REVISED
PLAN COMMISSION
MEETING NOTICE AND AGENDA
Thursday, March 18, 2021
7:00 PM
VIRTUAL ONLY

Discussion and Action Regarding a Recommendation to the Common Council for a Conditional Use Permit and Site and Building Plans for Zeilhofer Properties, LLC for Property Located at N4 W22540 Bluemound Road for the Purpose of Constructing a New Freestanding Two-Story Storage Building (PWC 0963997)

Date: February 15, 2021 (3/8/21 - A/E Comments in RED)
To: Mark Wershay, Zimmerman Architectural Studios, Inc.
From: Nick Fuchs, Planner & Community Development Director
RE: Zeilhofer storage building Conditional Use and Site & Building Plan Review

C1.30

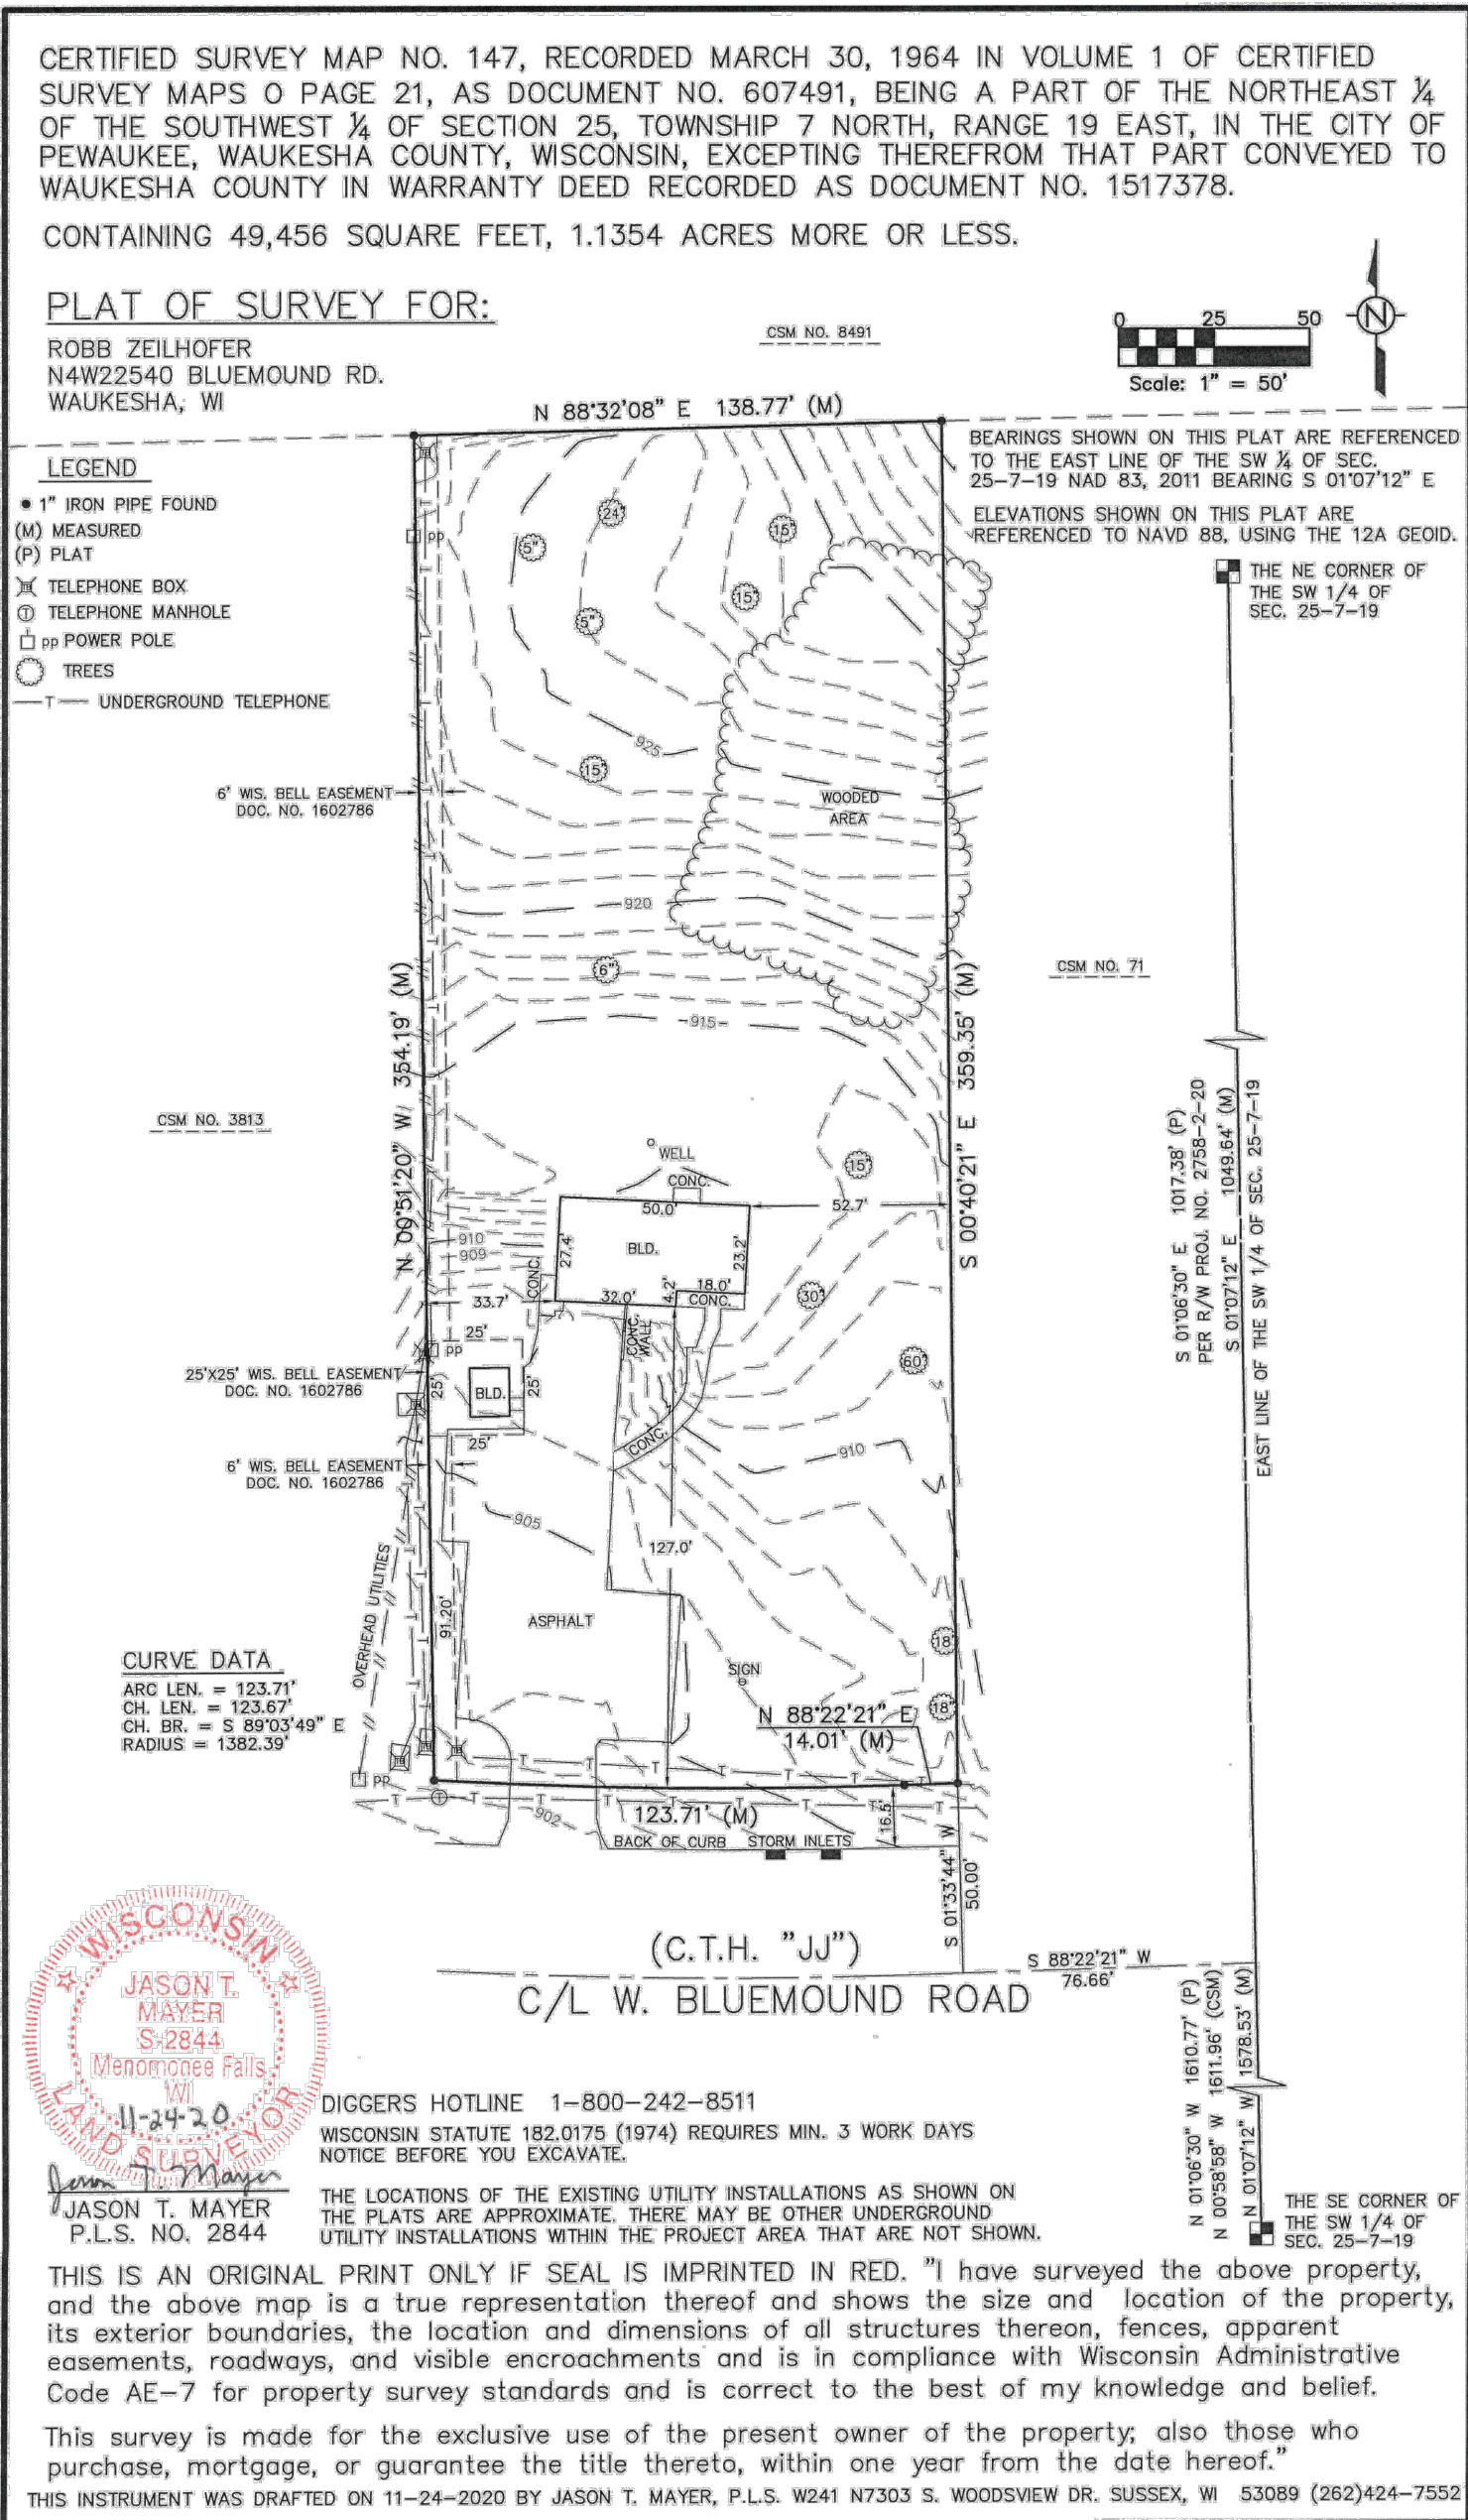
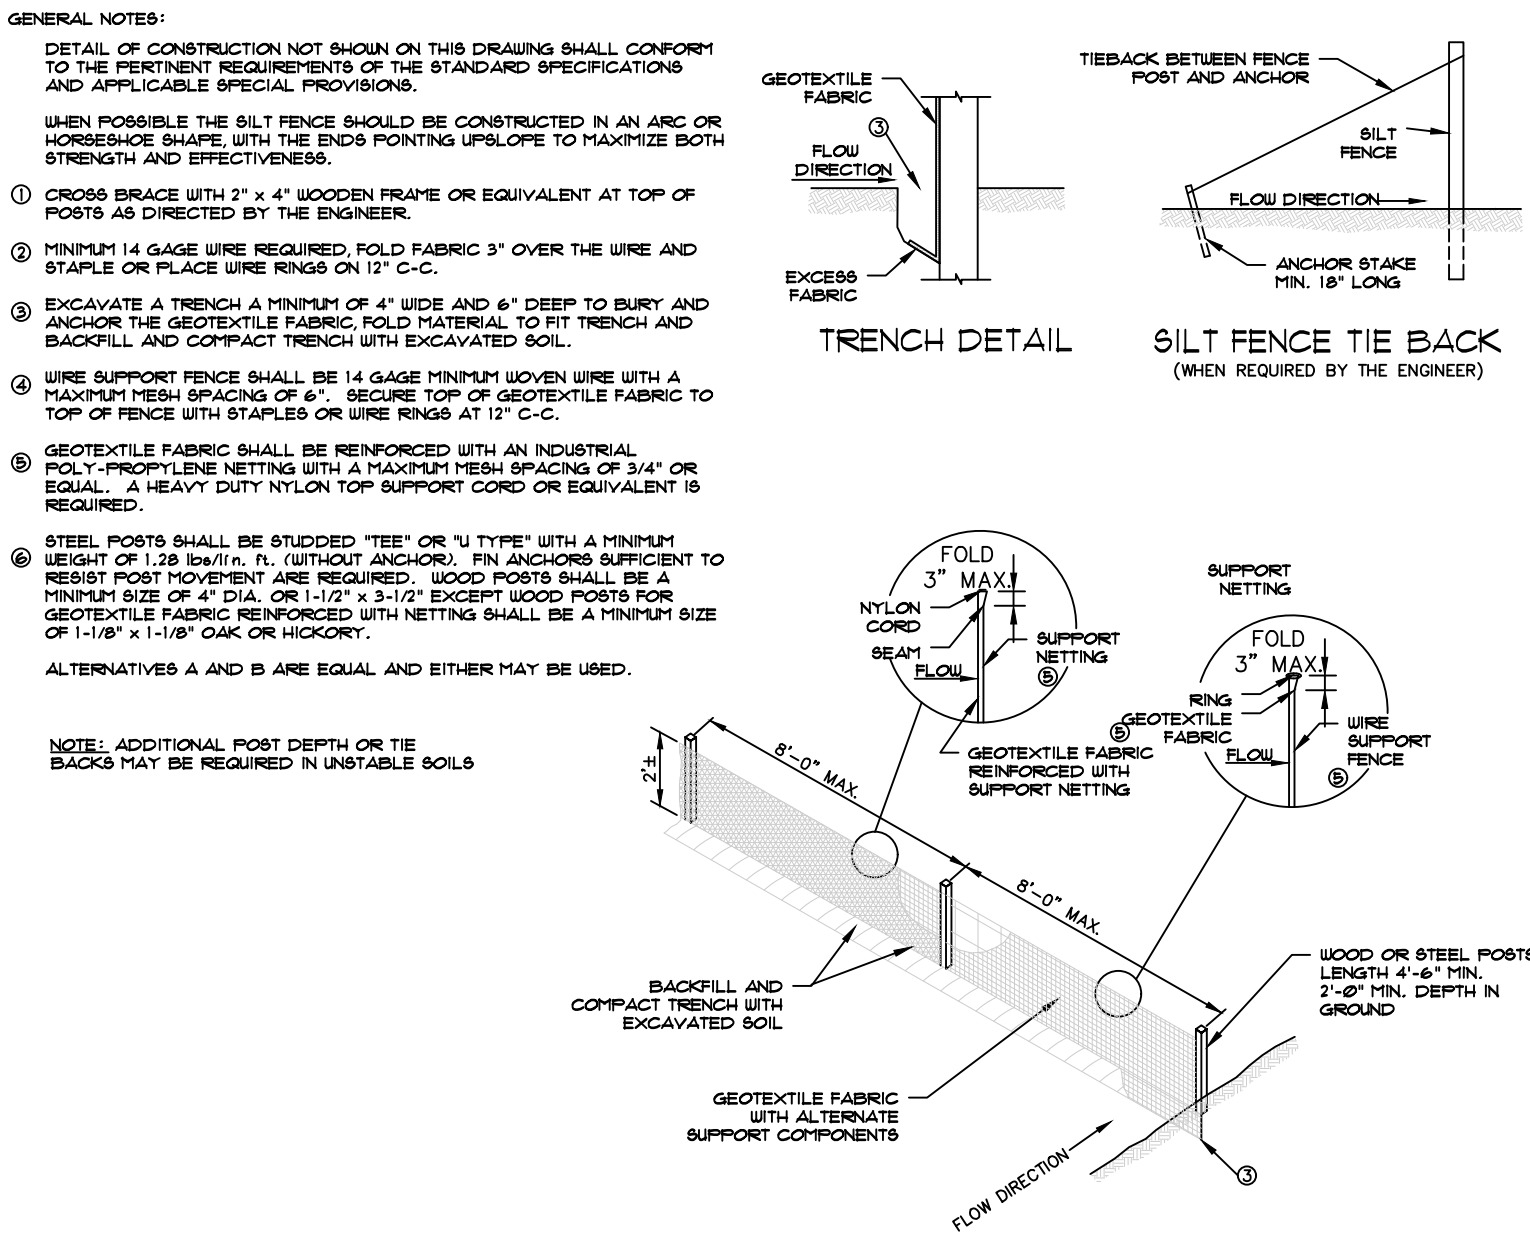
- c. The Demo plan does not appear to reflect the amount of tree removal required for the work shown on the Grading and Erosion Control Plan. **The demo area within the "Wooded area" has been expanded to reflect the grading and erosion control plan.**

C5.00

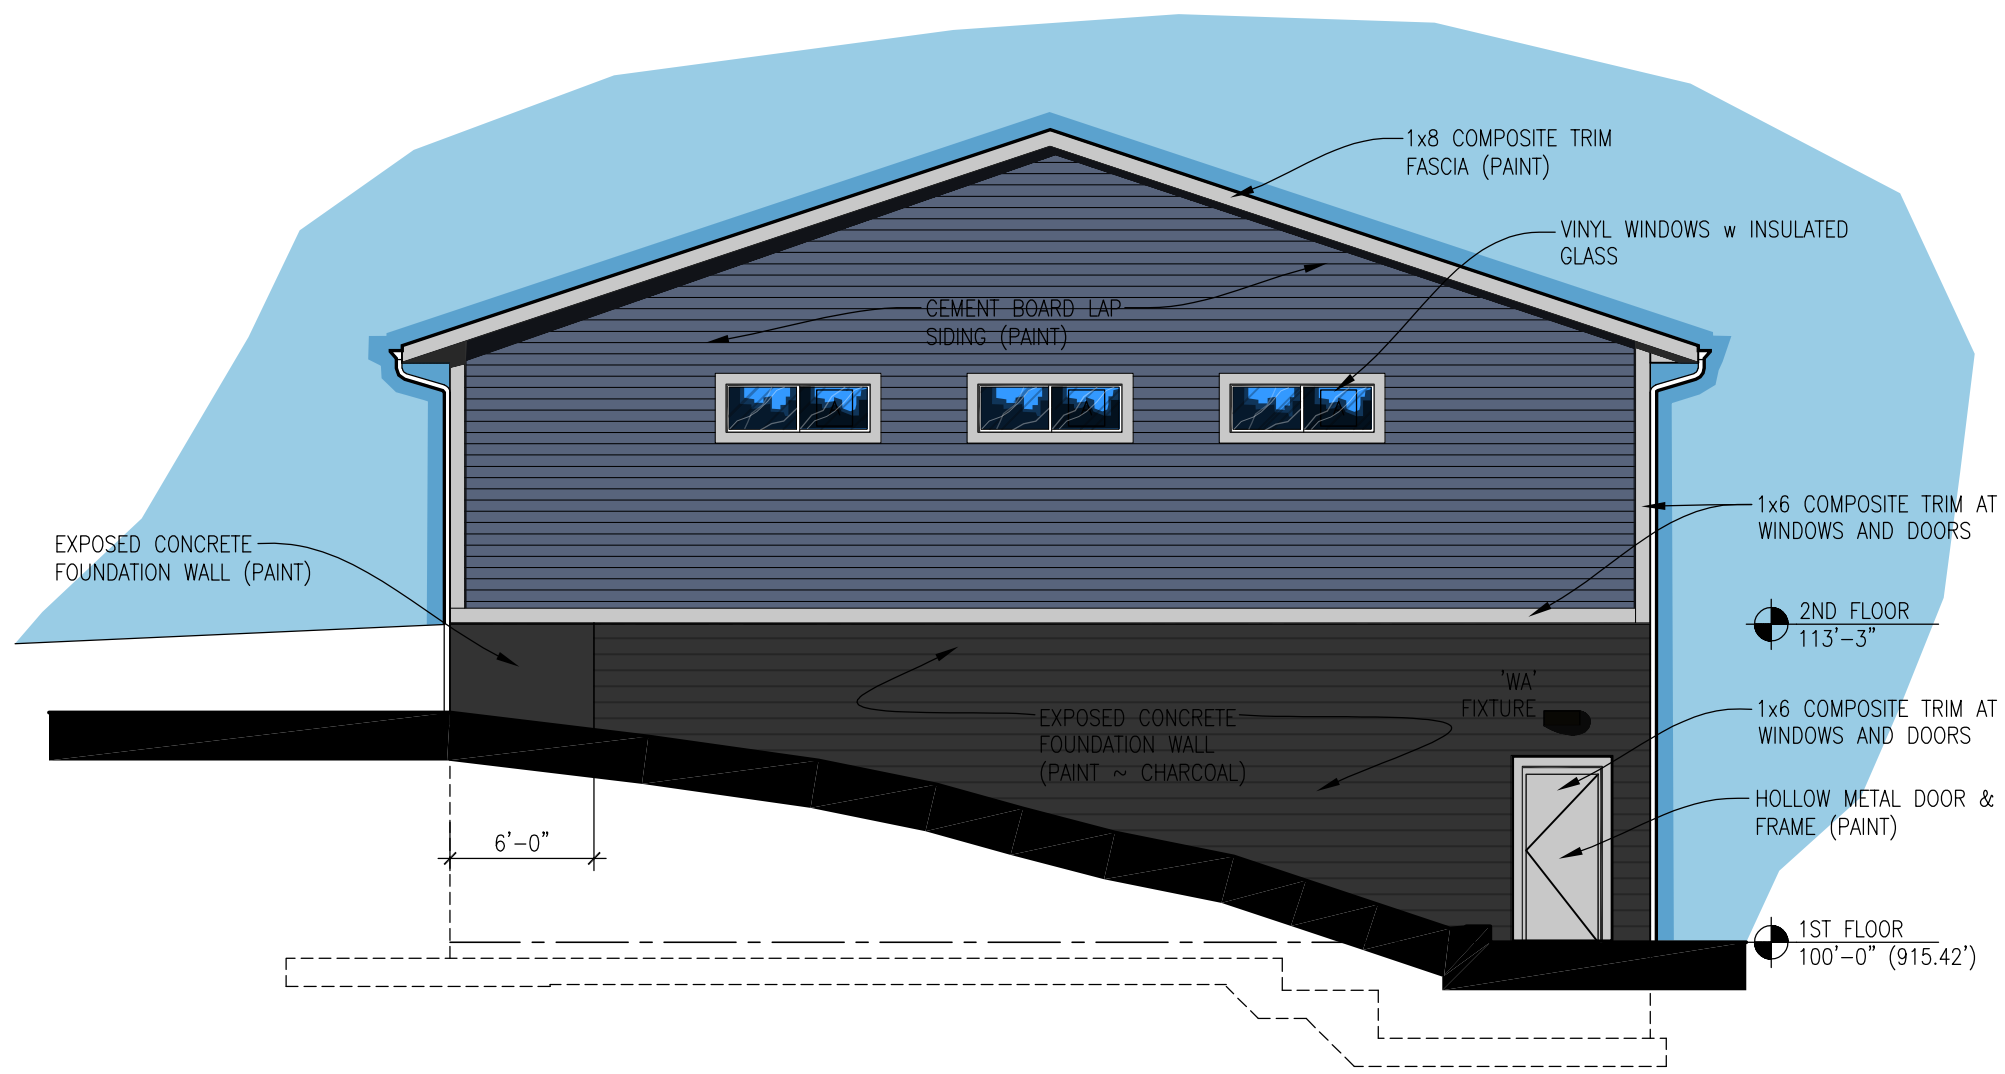
- e. Please remove the City's curb and gutter detail and driveway connection as this is Waukesha County's jurisdiction. **City curb and gutter, and driveway connection has been removed.**
